GT40: Fuel System – Revised

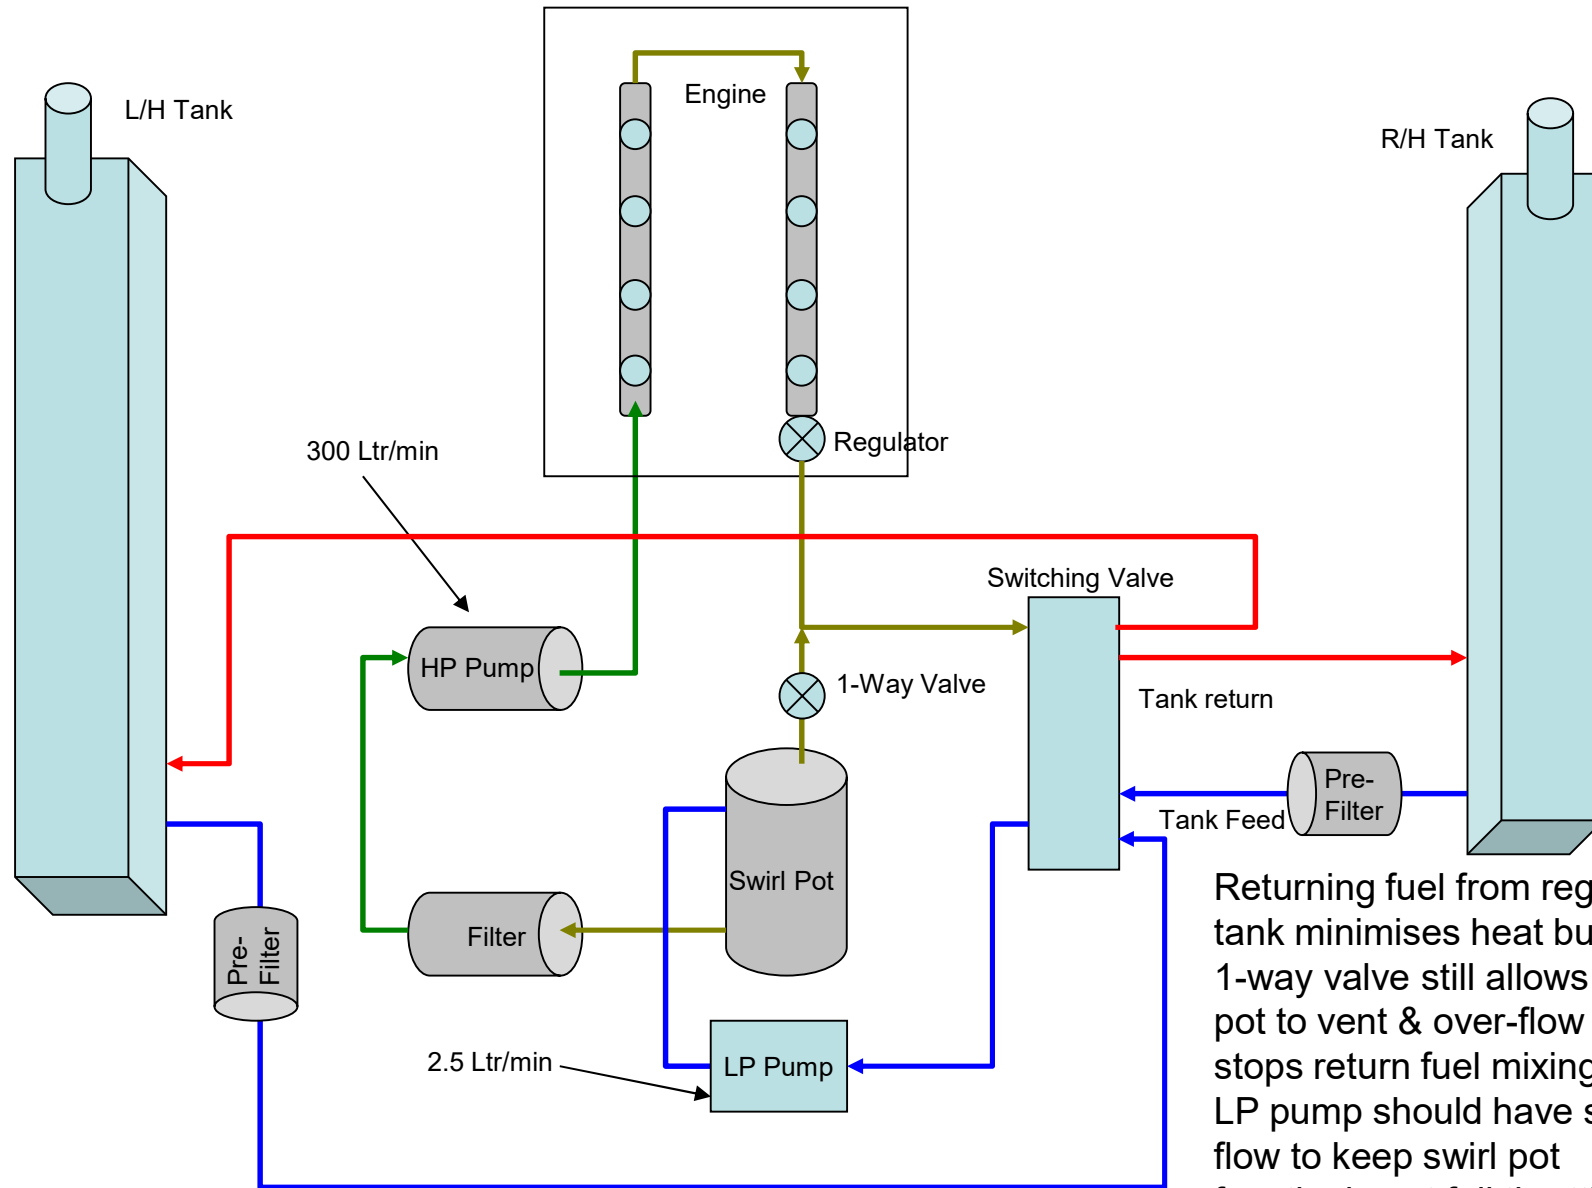
Returning fuel from regulator to tank minimises heat build up. 1-way valve still allows swirl pot to vent & over-flow but stops return fuel mixing LP pump should have sufficient flow to keep swirl pot functioning at full throttle
